A revised Chapter 5 is being submitted based on the number of changes required by the deficiency list and shifting of text to different pages due to these changes. This Chapter 5 submittal replaces the previous submittal in Volume 3. The following colored pages describe the edits that have been made along with the deficiency if the change directly addresses one. As in other sections, the Division's deficiency is in *italics* and the ACD responses are in regular font.

The following is a listing of the deficiencies for Chapter 5 followed by text describing how each deficiency is addressed:

SEDIMENT
IMPOUNDMENT 1
DESIGN & DETAILS
COAL HOLLOW
PROJECT
ALTON, UTAH
DRAWING: 5-28

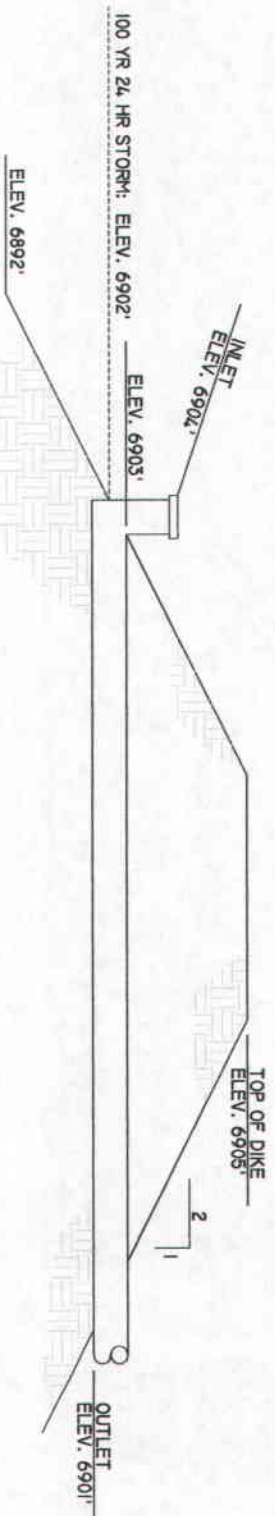
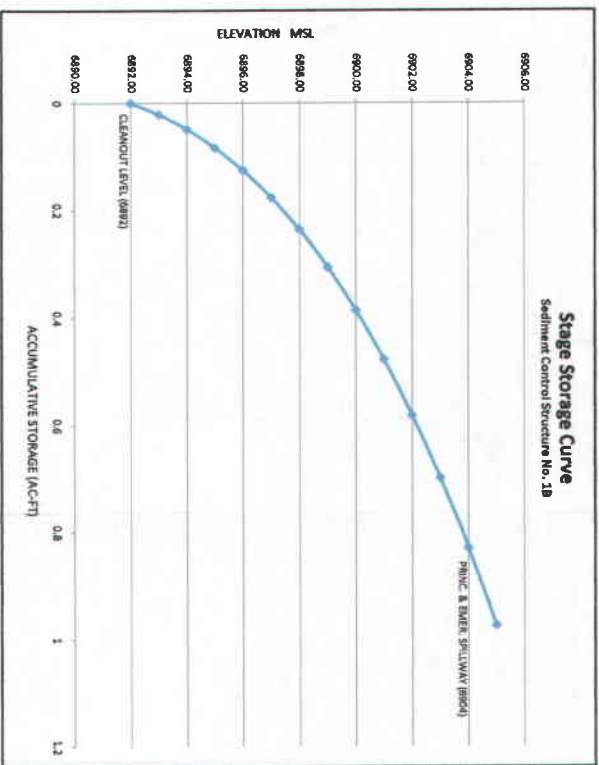
A professional engineer experienced in the design and construction of impoundments with assistance from a geotechnical expert has used current, prudent, engineering practices to design the proposed impoundments. The plans have been certified and a detailed geotechnical analysis has been provided. The certifications and drawings can be viewed in Drawings 5-25 through 5-31 and Appendices 5-1 and 5-2.

Detailed designs of impoundments can be viewed on Drawings 5-28 through 5-31. Locations can be viewed on Drawing 5-3 and 5-25.
